Office Action Summary

10/624,152

This is the first Office Action for application number 10/624,152 Modular Accessory Holder, filed on 7/21/03. Claims 1-3 are pending.

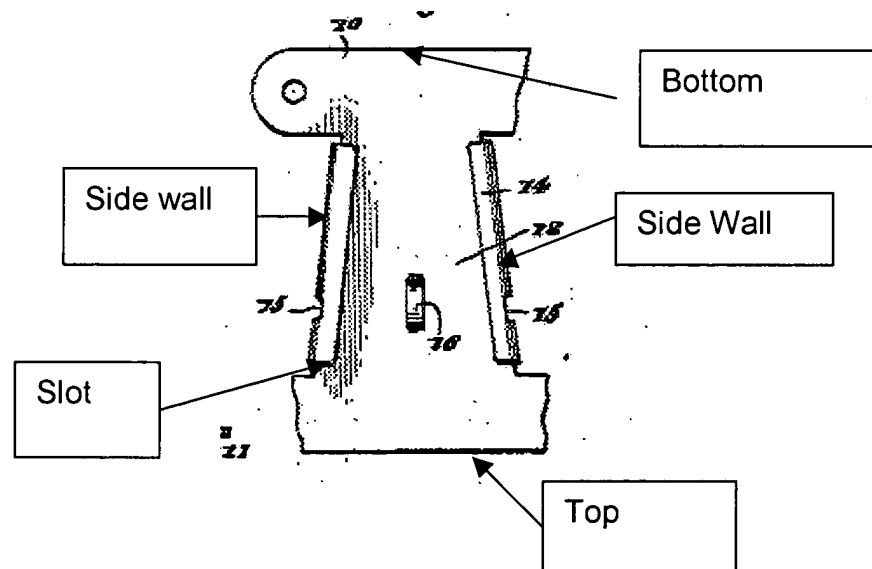
The patent to Schofield discloses a device having a receiver (10) fixedly attached to a fixed point, wherein the receiver has a top surface (See Drawing Below), and an open front, a slot opening in the top surface and descending downward therefrom having an upper portion and a lower portion, wherein the slot is bounded by a back wall (12), a front wall (14), and first and second side walls (See Drawing) which taper toward each other so that the upper portion is wider than the lower portion of the slot.

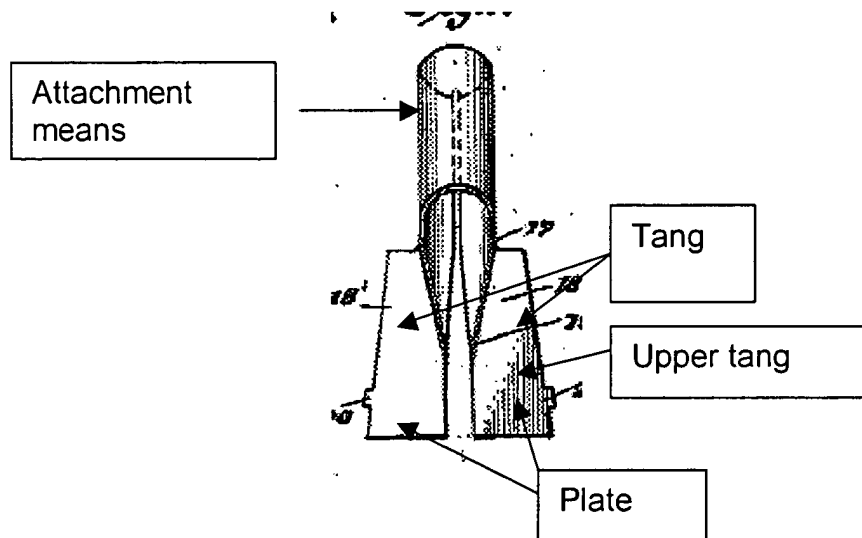
Shofield also discloses a modular mount (17, 18', 19, 20) including an attachment means (See Drawing Below), a plate (See Drawing), a tang (See Drawing) having a back wall, a front wall, a first and second side wall, the tang descending from the plate first and second steps (20) proximate to a junction between the tang and the plate, wherein the first and second side walls of the tang taper toward each other so that the upper portion of the tang is wider than the lower portion.
